CITY OF SARATOGA SPRINGS  
DESIGN REVIEW COMMISSION

Design Review Commission Meeting – Wednesday, November 16, 2016

**A. 2016.075 Obstarczyk Garage Demolition**

**RE: 147 Spring Street – Demolition of Accessory Structure and New Construction**

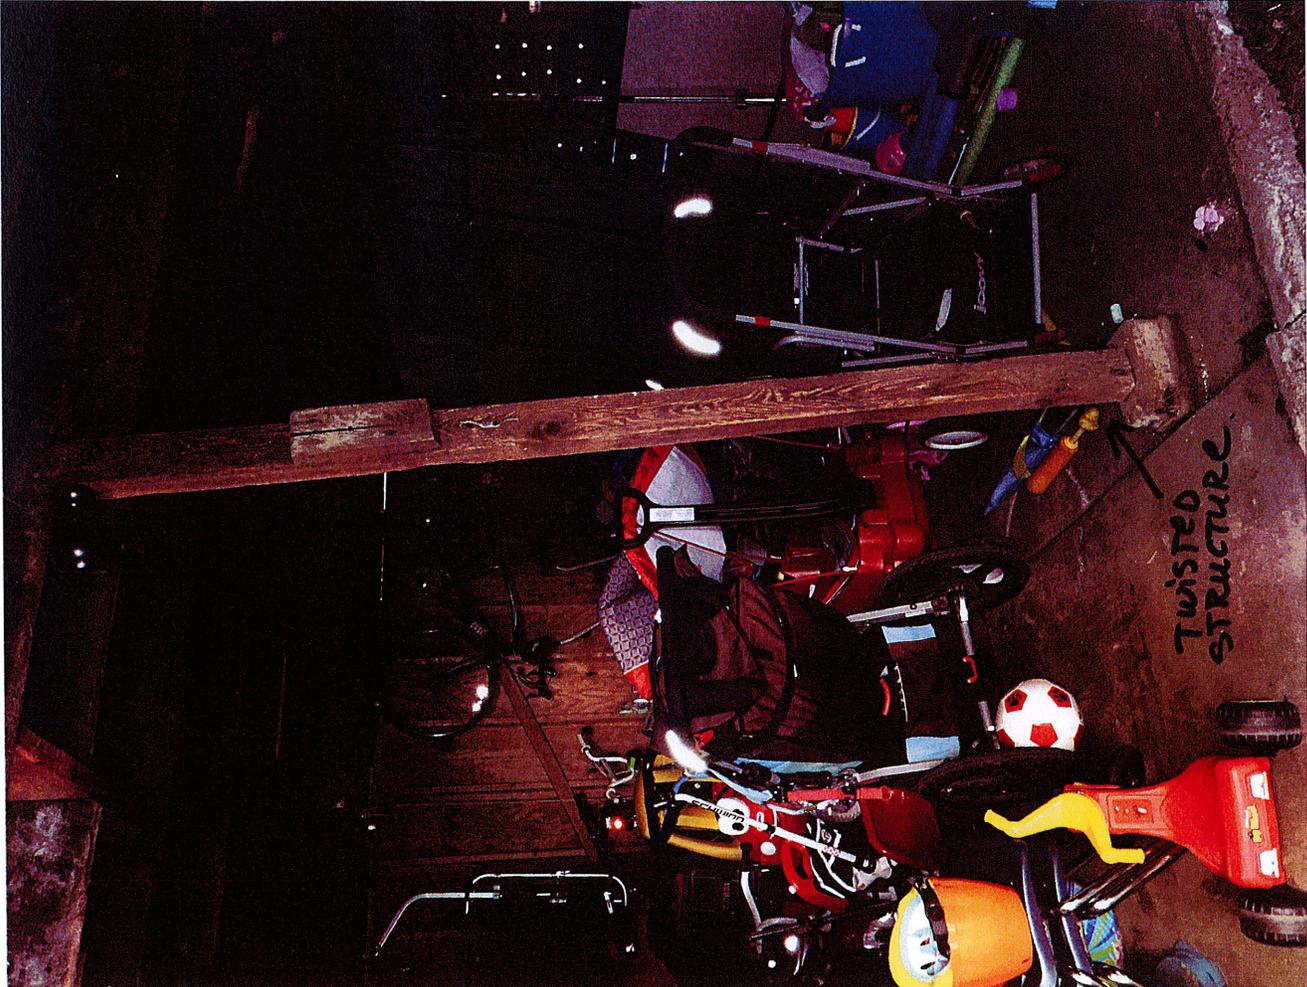
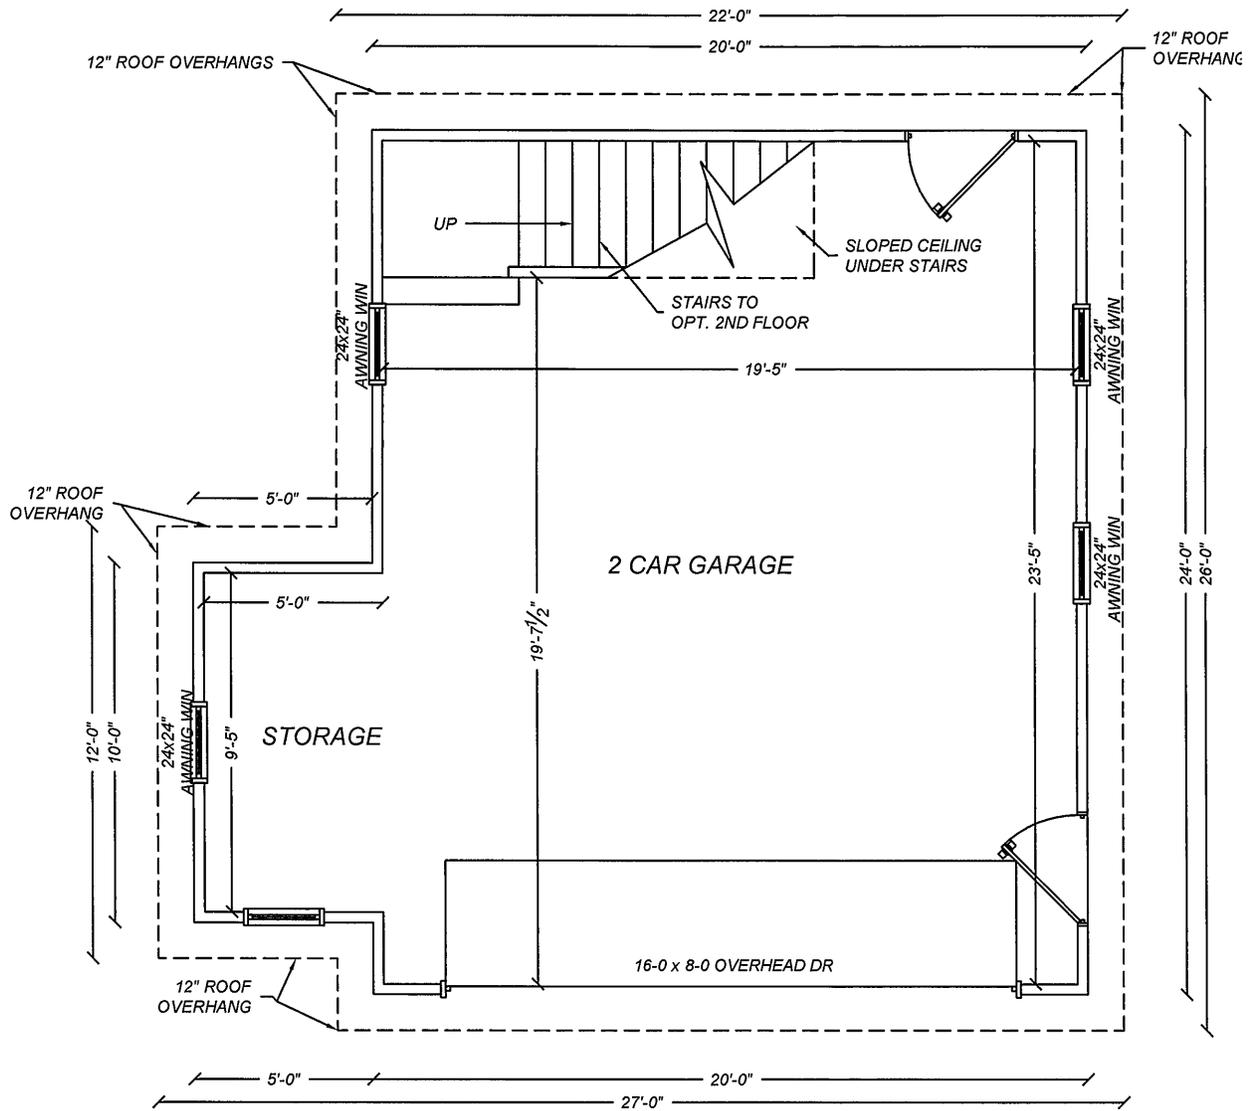
← LACK OF SILL PLATE AT WALL

TWISTED  
STRUCTURE

CORNER OF STRUCTURE  
of STRUCTURE  
skewed

THIS PORTION  
of wall  
framed straight

THIS PORTION  
of wall skewed  
TO MATCH TWISTED  
STRUCTURE
